Technical Service Information

THM 4L80-E

VIBRATION AND/OR LEAK AT EXTENSION HOUSING

Figure 1

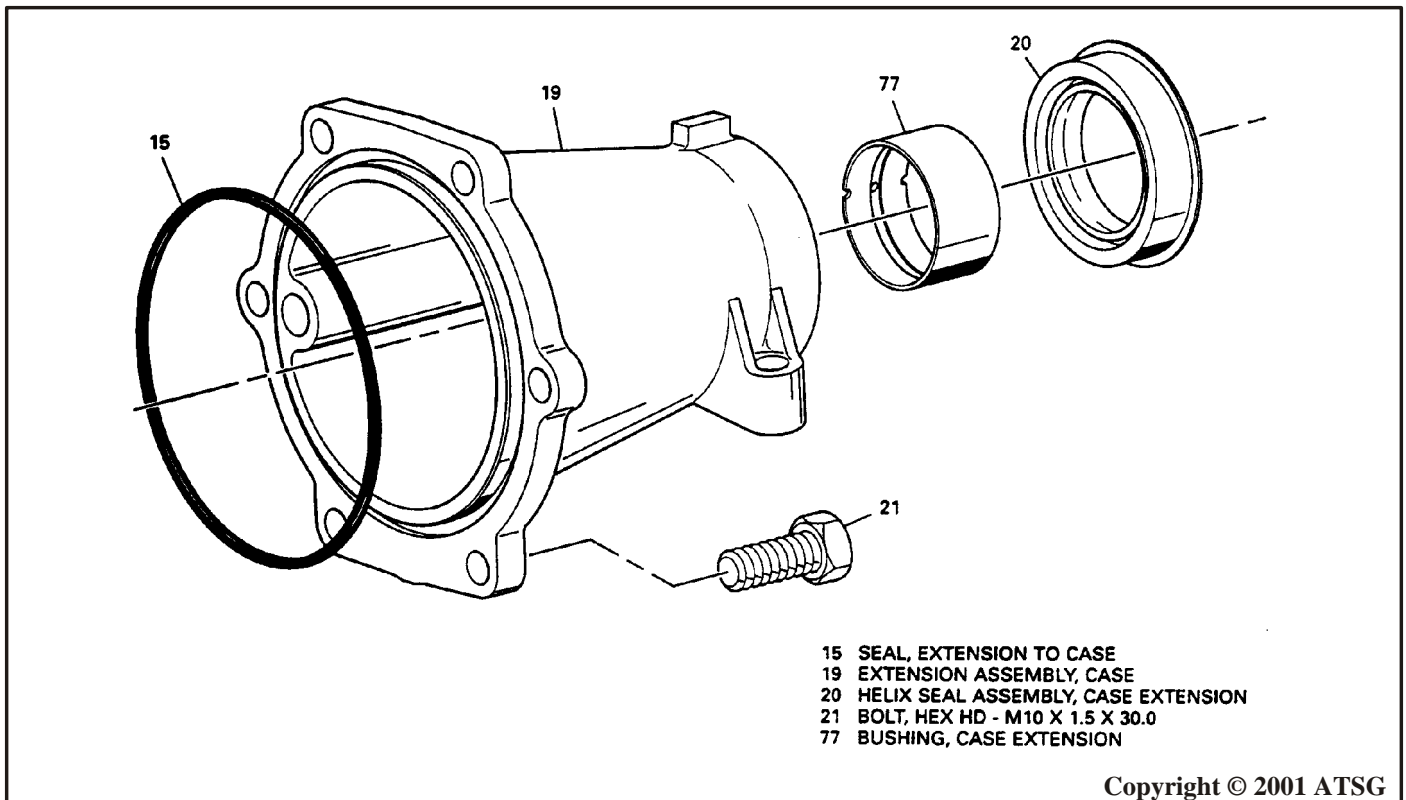
COMPLAINT: Some 1993 2WD model THM 4L80-E/4L80-EHD transmissions may leak transmission fluid from the extension housing seal even after seal replacement, and/or a vibration may be present in all ranges at all vehicle speeds.

CAUSE: The cause may be, the extension housing bushing not seated in the proper position, due to an oversized extension housing bore. This will allow the bushing to move rearward and interfere with the extension housing seal, creating the leak.

CORRECTION: If the extension housing bushing has moved, the extension housing **MUST** be replaced with OEM part number 8677464. Attempts to repair the extension housing by staking, or using Lock-tite to secure the bushing have been unsuccessful. Also install new extension housing seal, and lathe-cut "O" ring seal (See Figure 1).
